TITLE: Ash Tray Cover

BULLETIN NO. 246

Models Affected: 108 (Voyager) Serial 108-1  
through 108-2412

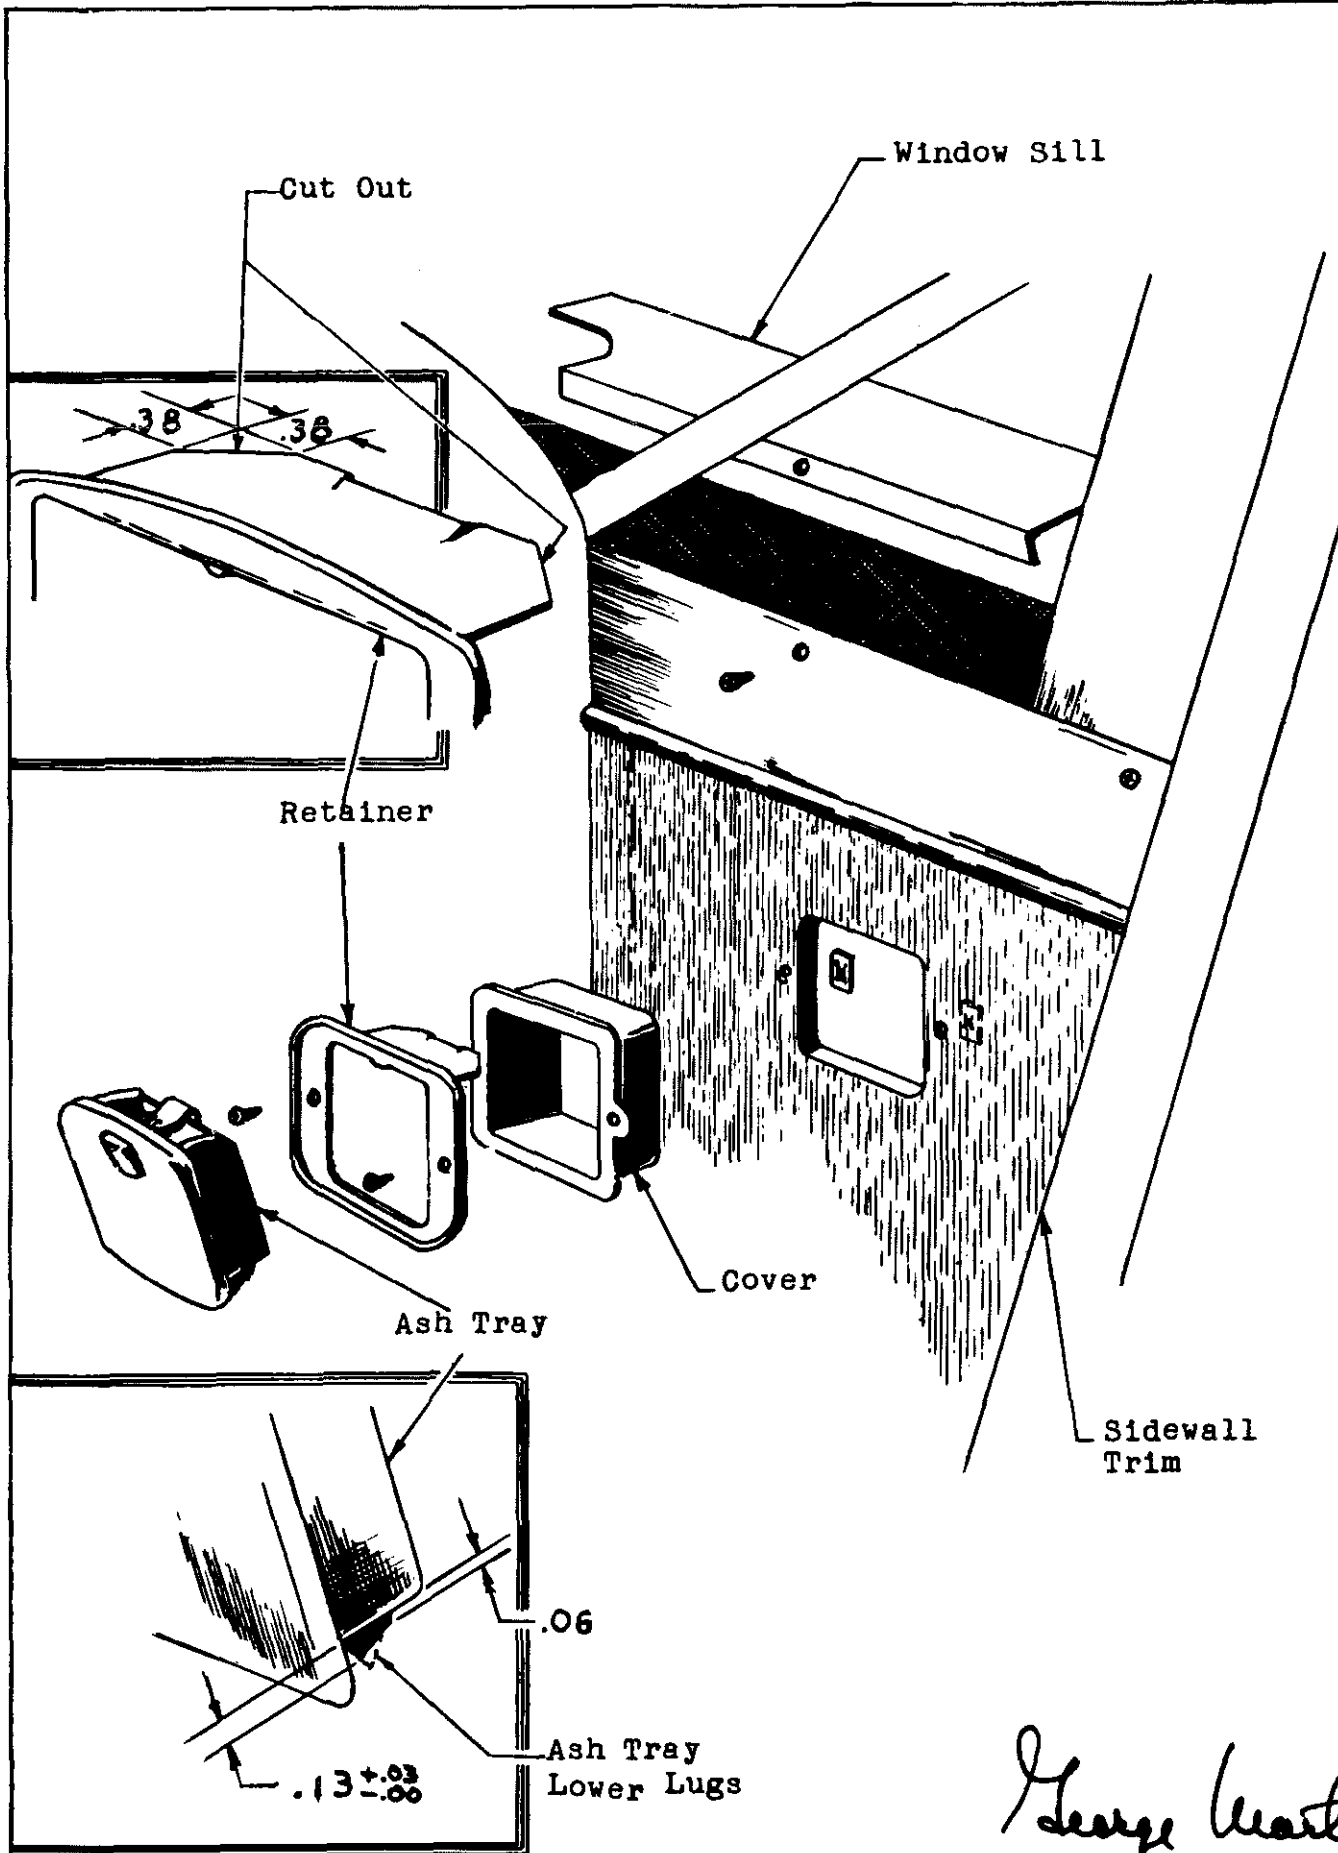
As an additional safety feature, we have developed and will install an ash tray cover on all airplanes beginning with serial 108-2413.

It is recommended that this cover be installed in those airplanes in the field that were delivered without this refinement. The part number of this cover is 108-3092099.

1. Remove ash tray and retainer attached to the sidewall trim.
2. Enlarge hole in trim sufficiently to accomodate cover.
3. Remove window sill at top of trim panel to permit access to Tinnerman nuts when reassembling ash tray retainer and cover to sidewall trim.
4. Modify retainer as shown on figure 1 so that retainer will seat in cover.
5. Insert cover and ash tray retainer, and secure to sidewall trim with new screws and Tinnerman nuts in the manner of the original installation. The nuts must be inserted from above, using long nosed pliers.
6. Reinstall window sill.
7. Modify ash tray lower lugs as shown on figure 1 so that ash tray will fit in retainer, and insert ash tray.
